Crow Butte Resources, Inc.

Responses to NRC Request for Additional Information

License Renewal Amendment Request

Source Material License SUA-1534

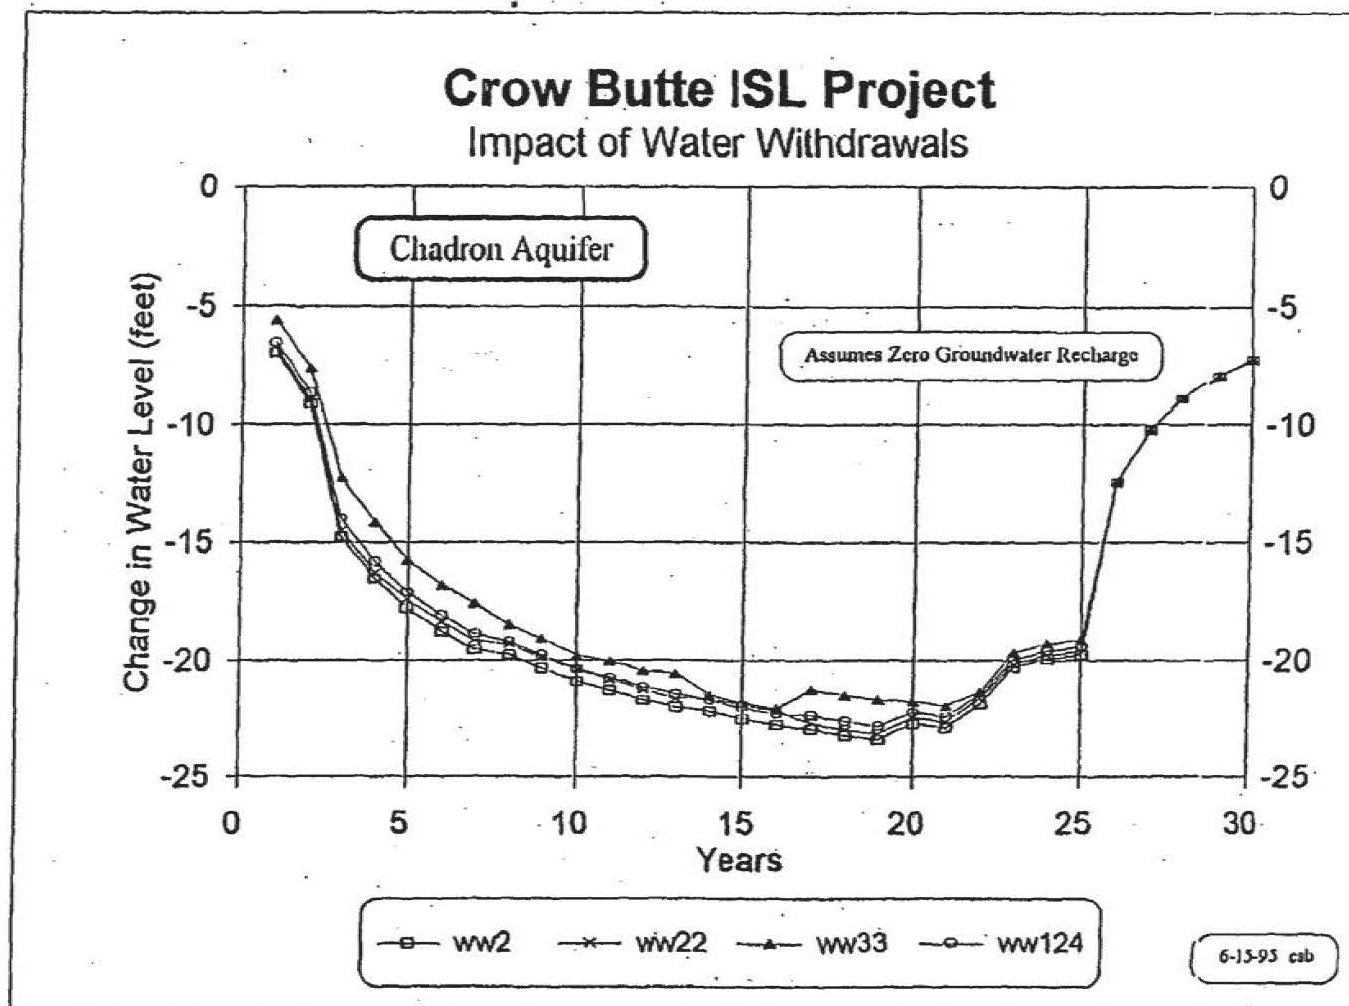
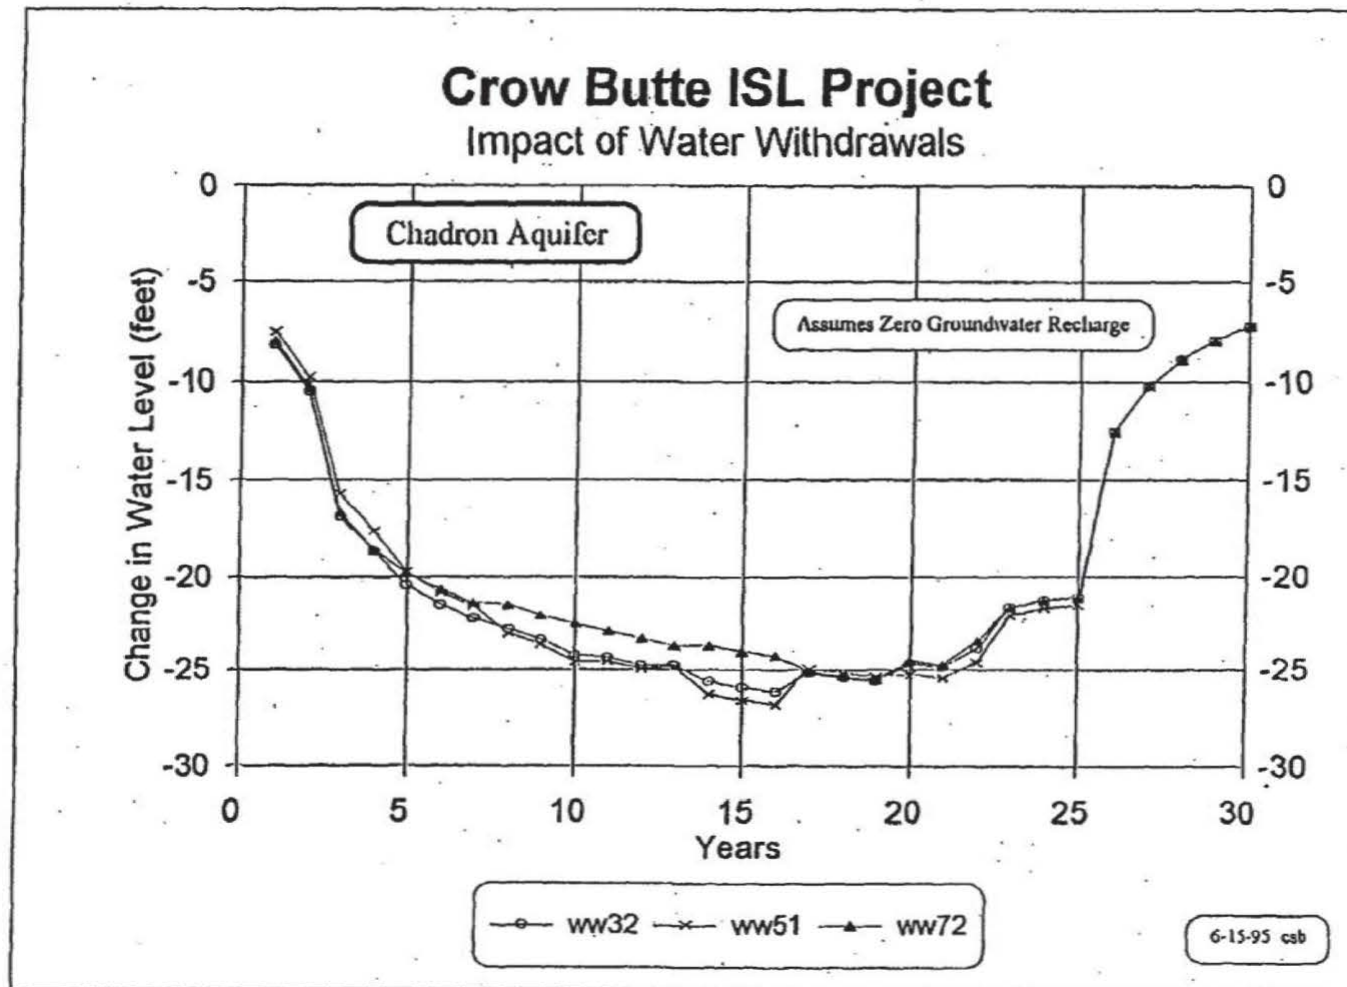
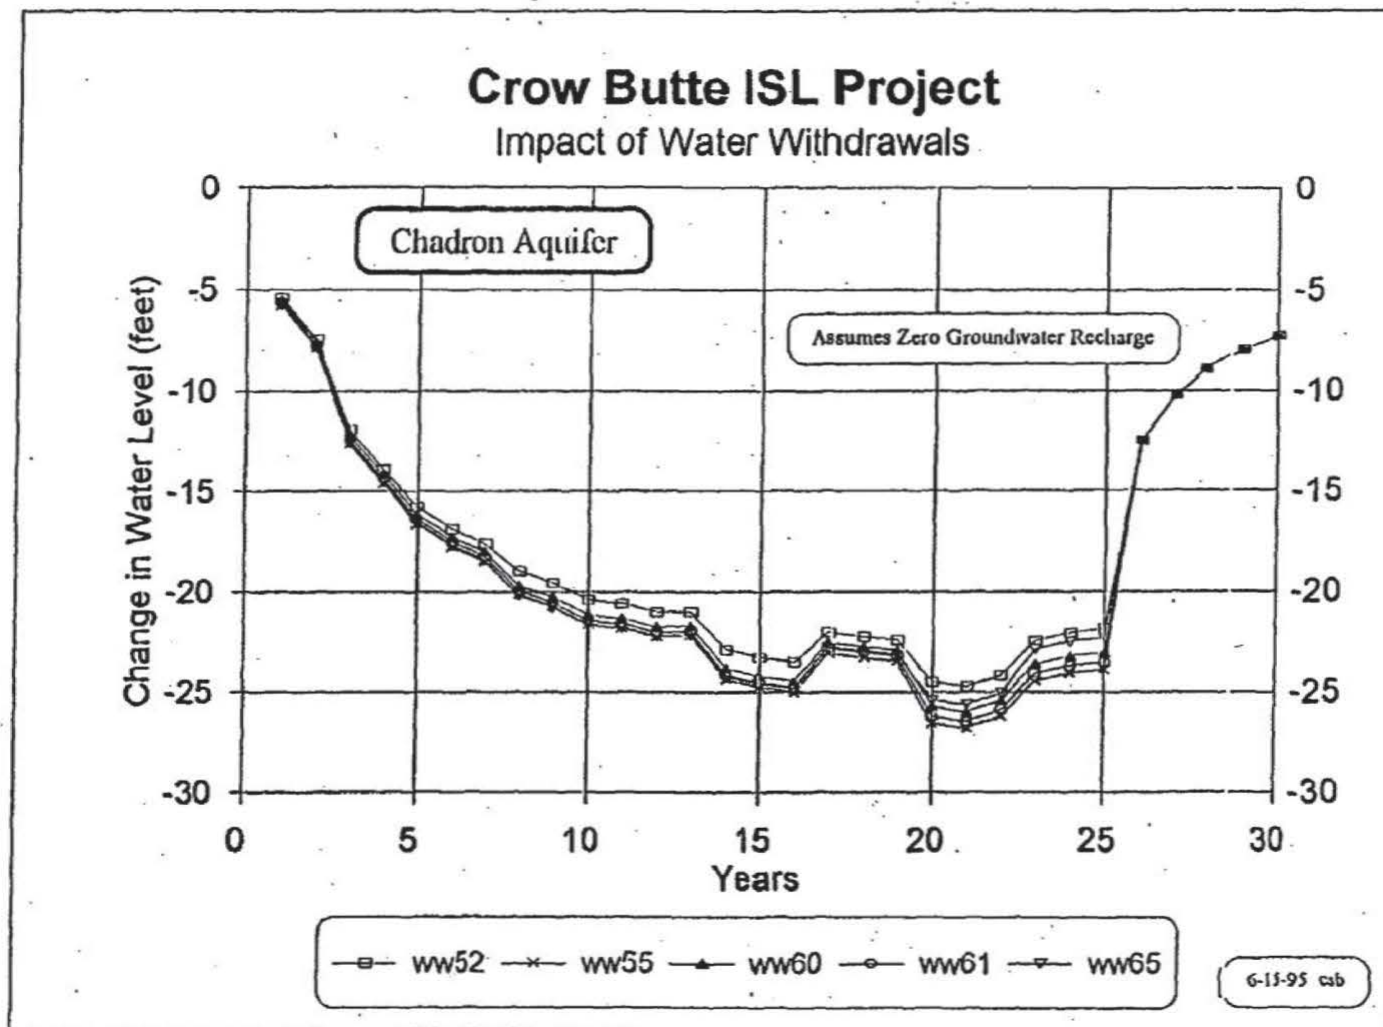
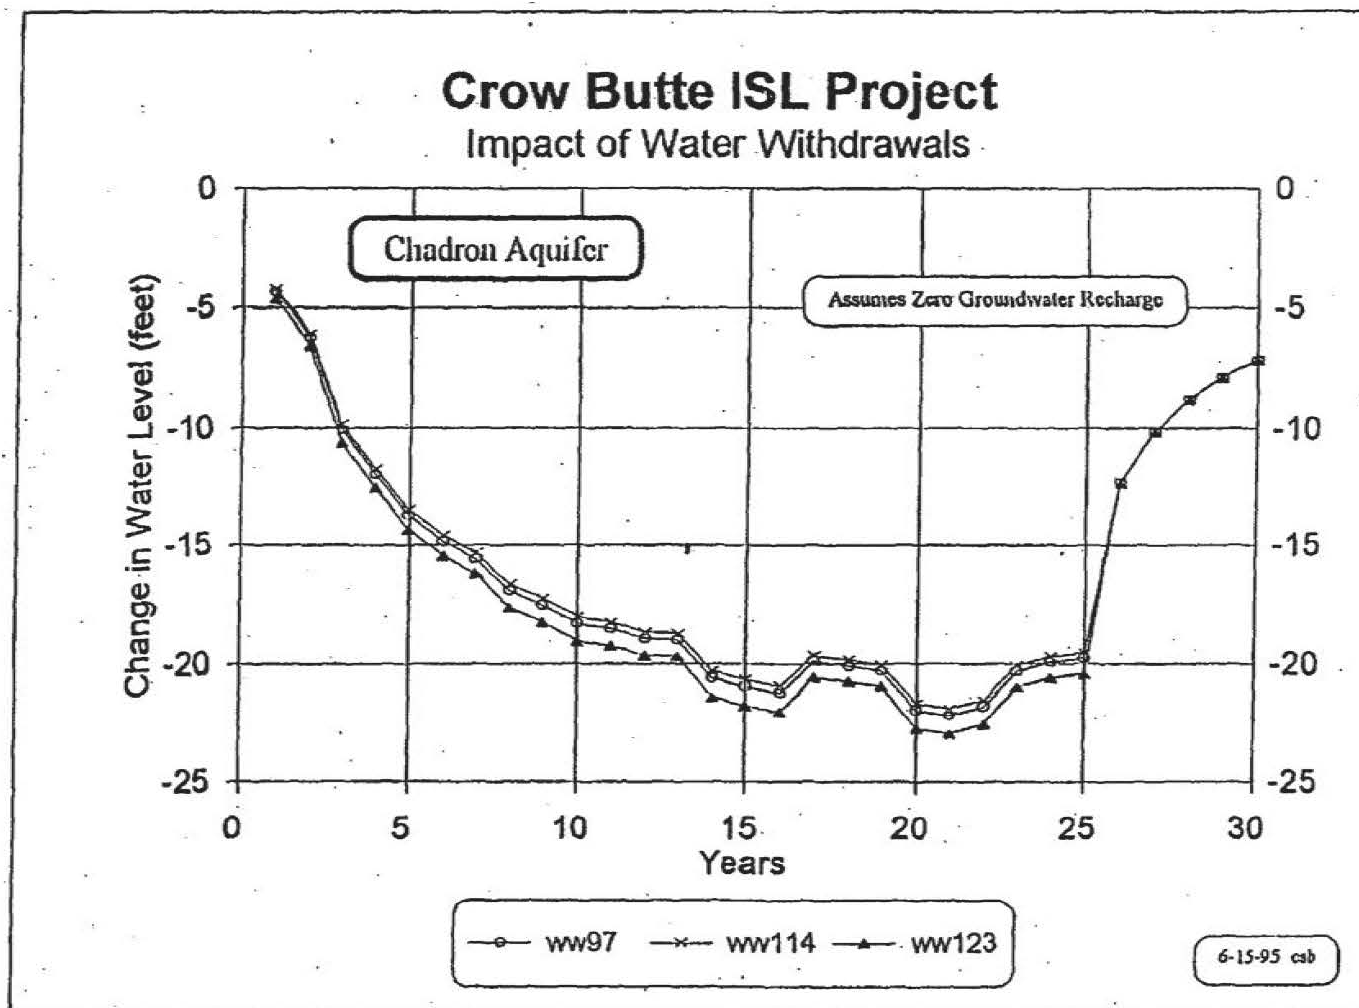
6. Referring to Table 7.12-2 in the application, please use current operational data to assess any changes to the maximum available drawdown.

Predicted maximum drawdowns for water wells averaged approximately -25 ft as shown on Table 7.12-2 of the application. These values were estimated assuming total net withdrawal rates of approximately 105 gpm. Actual net withdrawal rates were approximately double those used for the drawdown

estimates; therefore, these pumping rates would be assumed to result in actual average predicted drawdowns of approximately 50 ft. Table 2A, which is included as an attachment to this response document, presents a comparison of current projected drawdown estimates (2008 and 2009) to initial predicted drawdown estimates (1983) for wells 32, 72, 55, 97, and 123, where water level measurements are compared. Measured drawdowns range between 2.6 ft. for well 72 and -42.8 ft for well 32. These measured drawdowns are less than the predicted average drawdown of -50 ft referenced above, which would validate drawdown predictions.
